SHAENFIELD PLACE
PRELIMINARY OVERALL DEVELOPMENT PLAN
No. 708

Re: Shaenfield Place

POADP # 708

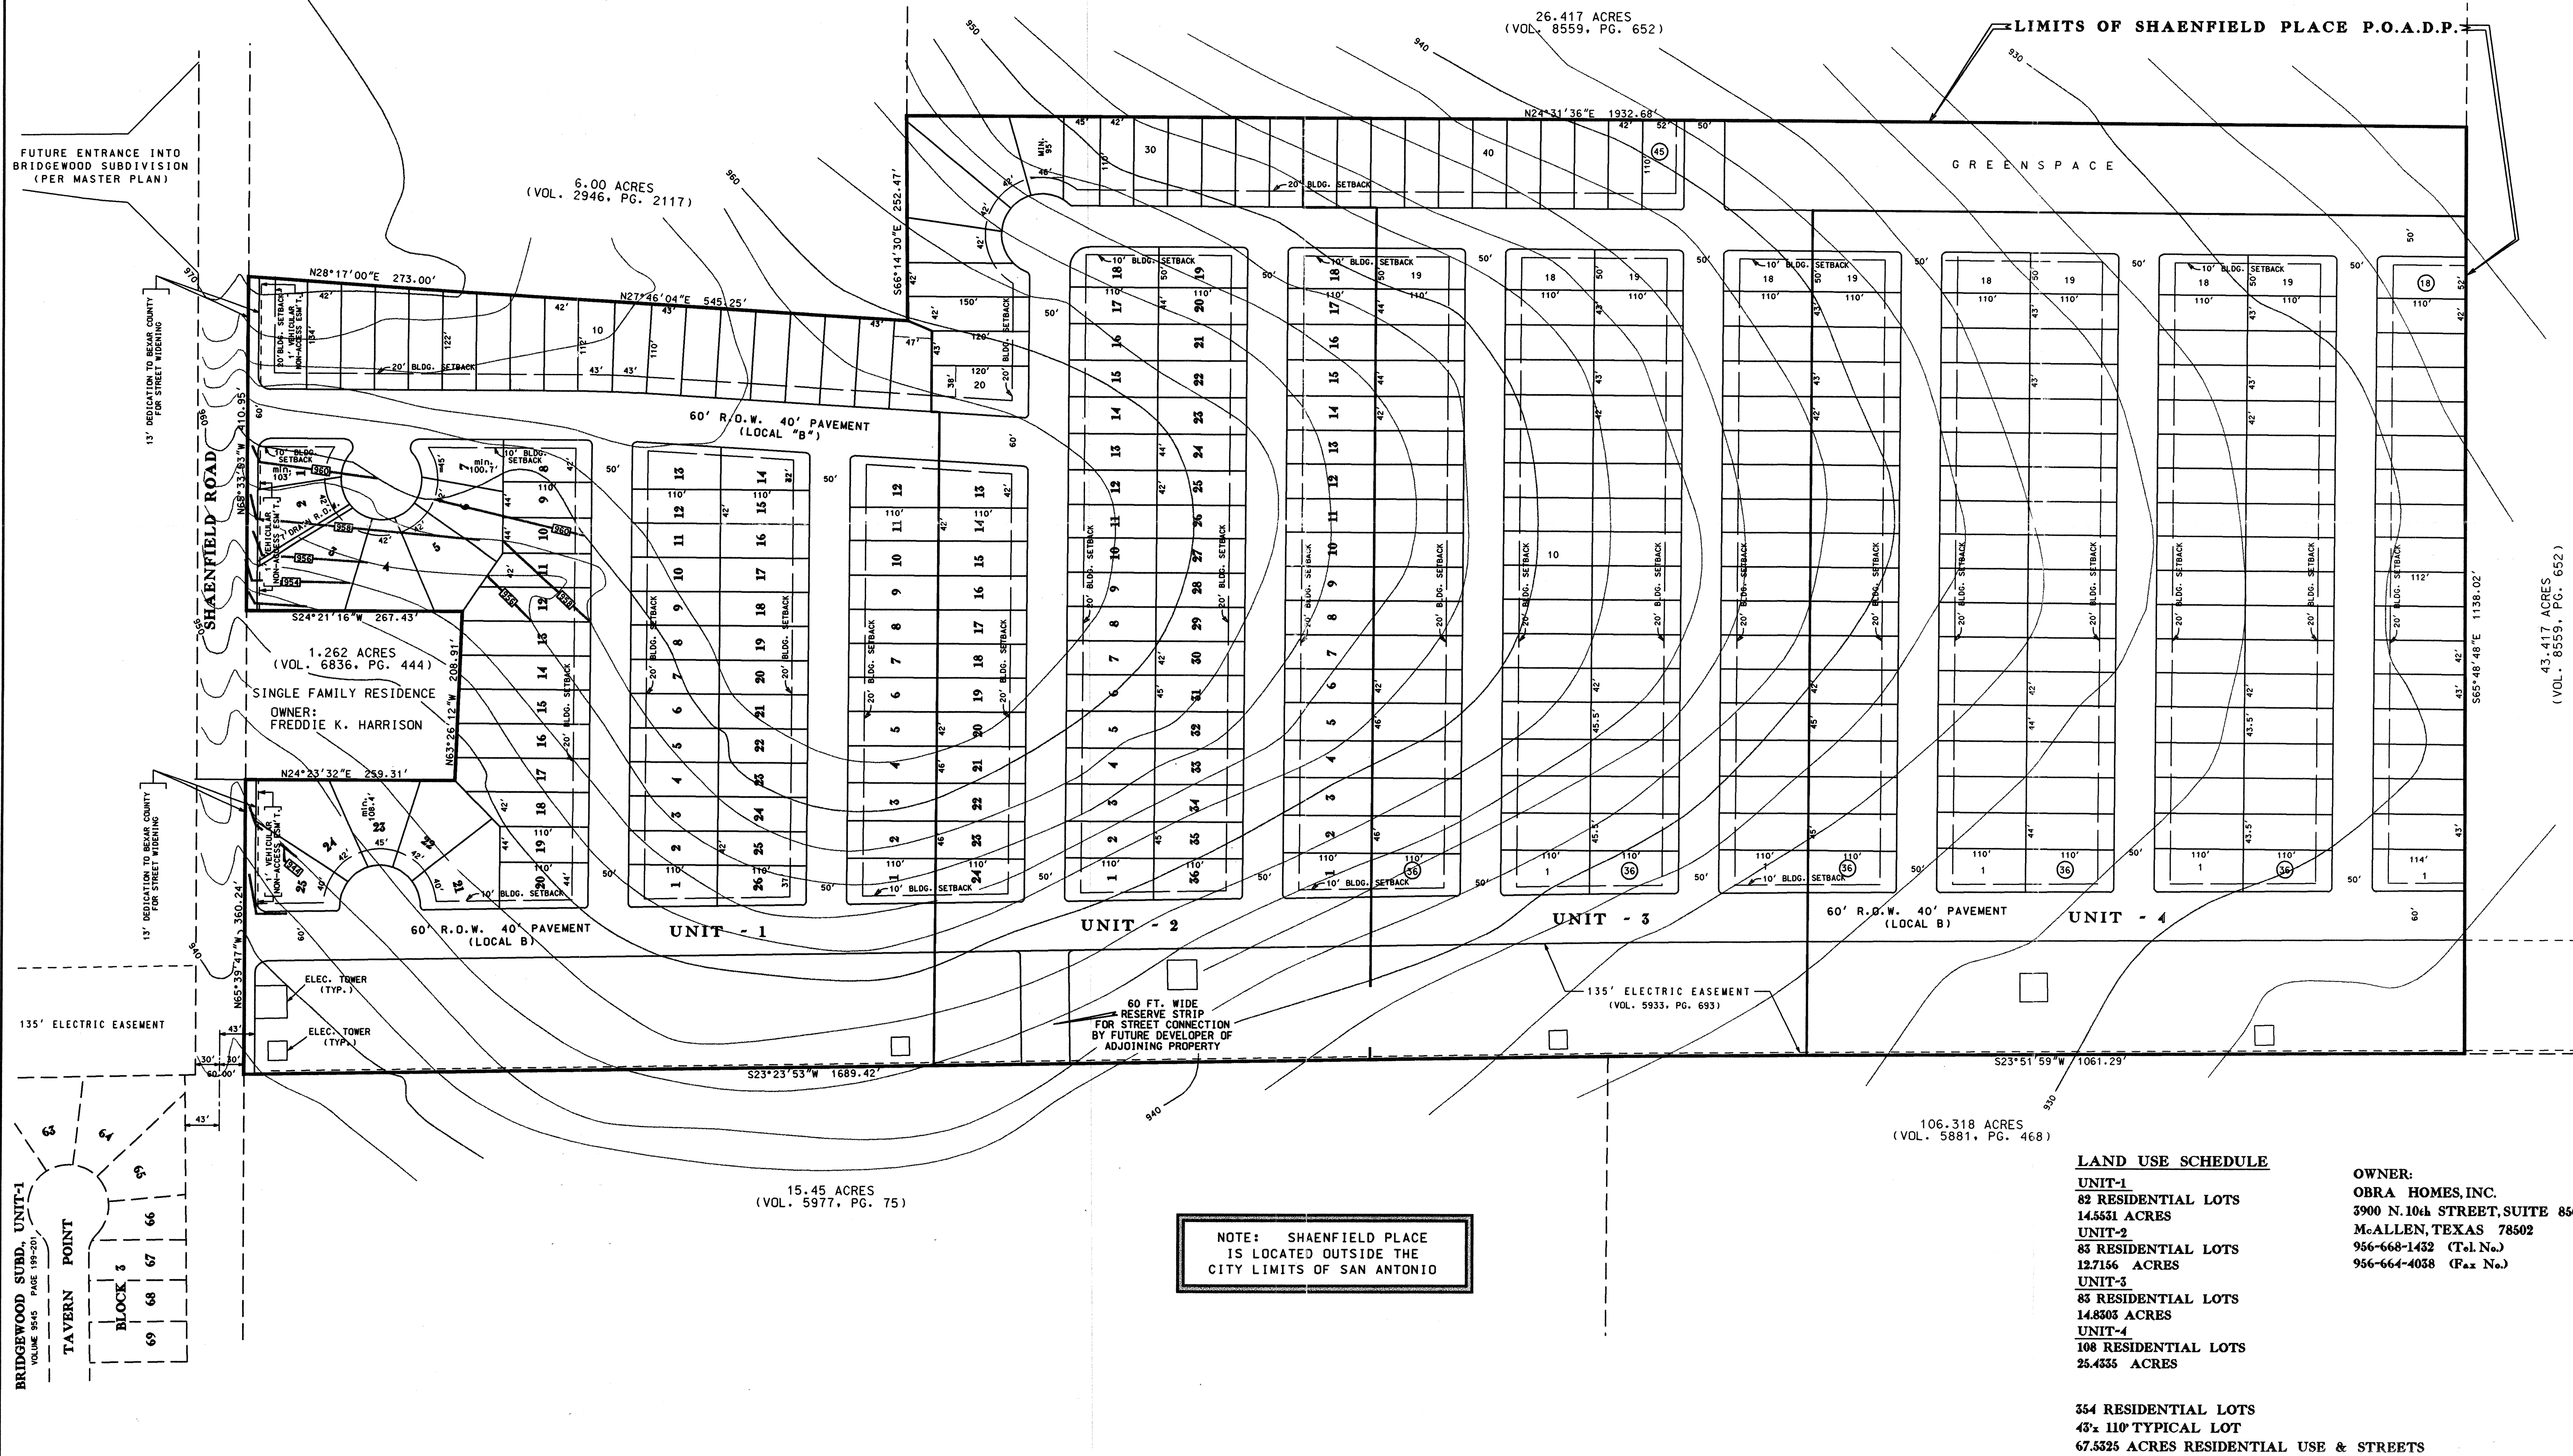
The City Staff Development Review Committee has reviewed Shaenfield Place Subdivision Preliminary Overall Area Development Plan. Please note that your plan was not accepted, based on the following:

1.) Sec. 35-2075 Information Required

- (a) Provide a 1' non access esm't along the rear of lots backing – up to Shaenfield Rd.
- (b) Show property owner and land use for out tract.
- (c) show existing entrances to Bridgwood across from this proposed POADP.
- (d) Both entrance streets will require 60' R.O.W.
- (e) Please annotate the perimeter of the project.
- (f) Access needs to be provided to the adjoining properties for connectivity.
- (g) An approved T.I.A. will be required.
- (h) Please use new application form (attached) fill out and resubmit.

Comments: SHAENFIELD ROAD IS ON THE MTP REQUIRING
A MIN. 80' ROW. PROPOSE POADP ADDRESS THOROUGHFARE

show contiguous POADP - Bridgemoor
address PIV comments regarding
connections
any unit line statement

Comments: TIA REQUIRED

Comments: Saw existing development across
from Shaenfield Road.
Increase ROW from 50' to 60'
will be used as a collector in lieu of
local A street.

REVISIONS:	DATE	NO.	DESCRIPTION	BY
1	07/17/01	1	REVISED STREET R.O.W. TO LOCAL "B"	R.A.L.
2				
3				
4				
5				
6				
7				
8				
9				
10				
11				
12				
13				
14				
15				
16				
17				
18				
19				
20				
21				
22				
23				
24				
25				
26				
27				
28				
29				
30				
31				
32				
33				
34				
35				
36				
37				
38				
39				
40				
41				
42				
43				
44				
45				
46				
47				
48				
49				
50				
51				
52				
53				
54				
55				
56				
57				
58				
59				
60				
61				
62				
63				
64				
65				
66				
67				
68				
69				
70				
71				
72				
73				
74				
75				
76				
77				
78				
79				
80				
81				
82				
83				
84				
85				
86				
87				
88				
89				
90				
91				
92				
93				
94				
95				
96				
97				
98				
99				
100

Mike, submitting the latest plans for review.
We made a minor change which involve CPS.
CPS didn't want our street R.O.W. (east entrance to
subdivision) to overlay into their 135 ft Electric Esm't.
Therefore we revised plan.
Questions, just call me.

Sending you the latest POADP. Called out **Collector Street** as requested by Street & Drainage. If you have any questions or need additional information please call us, thanks.

Michael, made corrections as requested per your letter dated April 24th. The TIA report has been submitted to Traffic as of March 30th. If you have any questions or need additional information please call us, thanks.
